Subject: McGuire Nuclear Station
Docket Numbers 50-369 and 50-370

Catawba Nuclear Station
Docket Numbers 50-413 and 50-414

Topical Report DPC-NE-3004P, Revision 1
TAC Nos. MA5511, MA5512, MA5517, M15518

Response to NRC Questions Regarding DPC-NE-3004, Revision 1

FIGURE 2-1

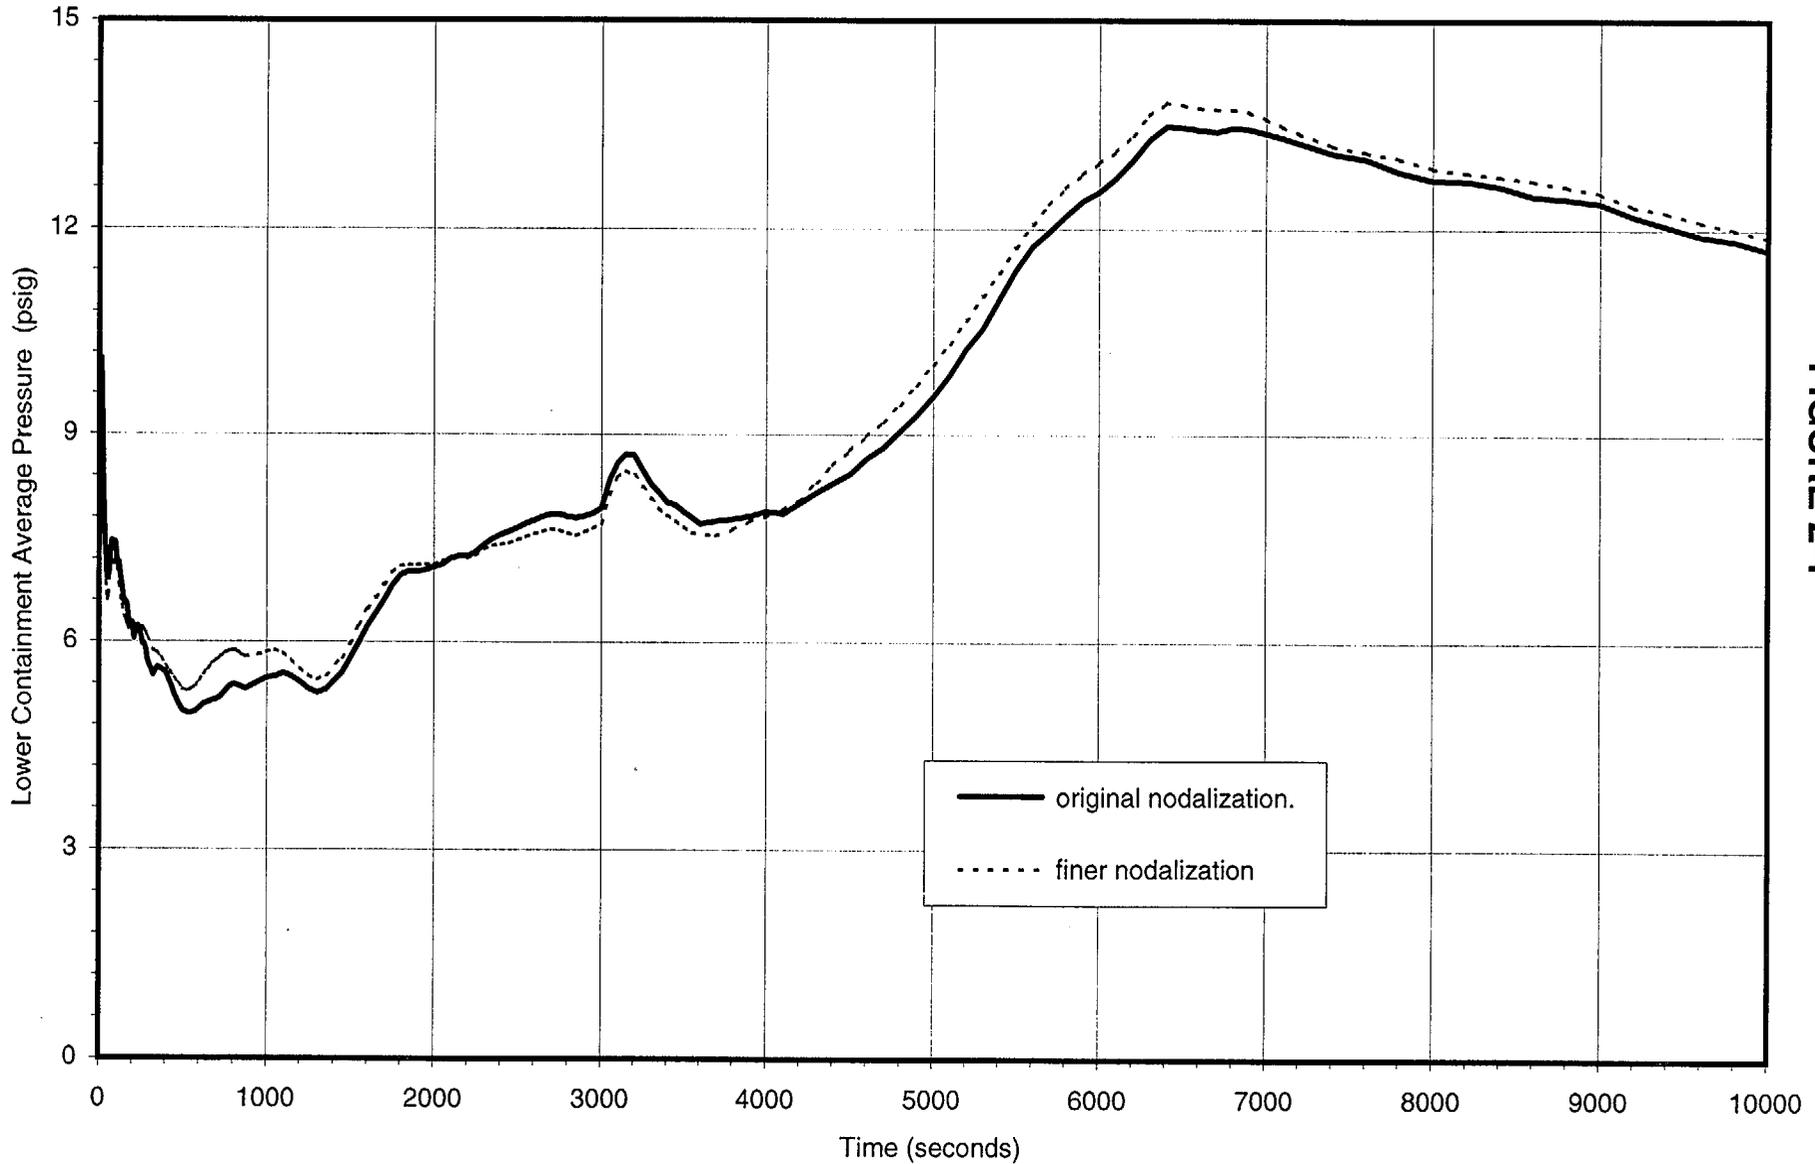
2. The proposed renodalization could affect the code’s ability to estimate the thermal-hydraulic response of the ice condenser. In order to conclude that the potential effects of renodalization are acceptably small, it would be useful to have a comparison of the pressure / temperature response of the ice condenser / containment system for selected DBA scenarios.

The containment pressure prediction (Figure 2-1) demonstrates that there is very little difference in the pressure response between the GOTHIC analyses with the original model and the model with the finer nodalization in the ice condenser region. The model with the finer nodalization in [] of the ice condenser region gives a containment peak

pressure that is about 0.3 psi higher than the original model. Both models result in peak pressures below the containment design pressure of 15 psig.
